**Technical Service Bulletin**

SUBJECT:			No:	TSB-18-32-001
TORQUE UPDATES: UNITS OF TIGHTENING TORQUE & NUMERICAL VALUE FOR POWER PLANT MOUNT - SERVICE MANUAL REVISION			DATE:	December 2018
			MODE	.: See below
CIRCULATE TO:	[] GENERAL MANAGER	[X] PARTS MANAGER		[ <b>X</b> ] TECHNICIAN
[X] SERVICE ADVISOR	[X] SERVICE MANAGER	[X] WARRANTY PROCESS	OR	[] SALES MANAGER

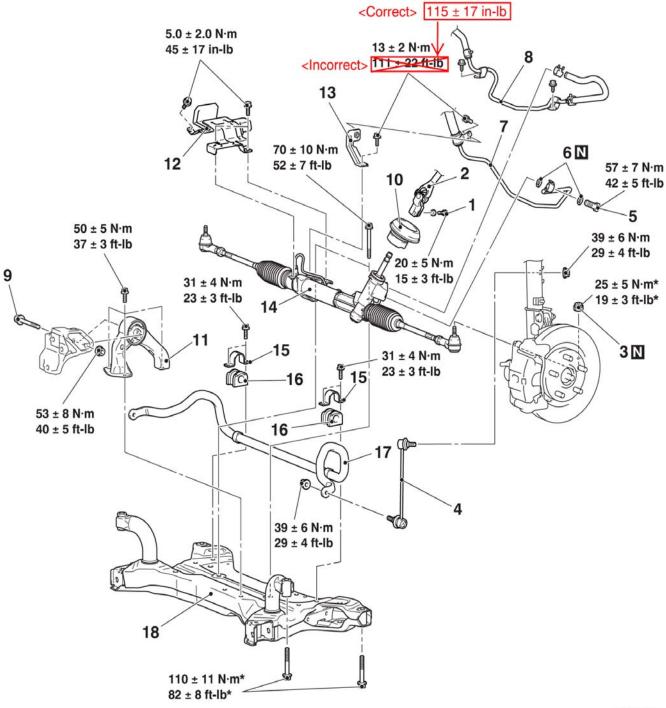
This TSB updates the Power Plant Mount section of the affected Service Manuals to correct the tightening torque for the Crossmember Removal Service Points.

Please make the indicated changes to the 2008 - 2010 Lancer, 2009 & 2010 Lancer Sportback, 2011 Lancer/ Lancer Sportback Evolution Service Manual, Group 32 - Power Plant Mount -> Crossmember -> Removal Service Points.
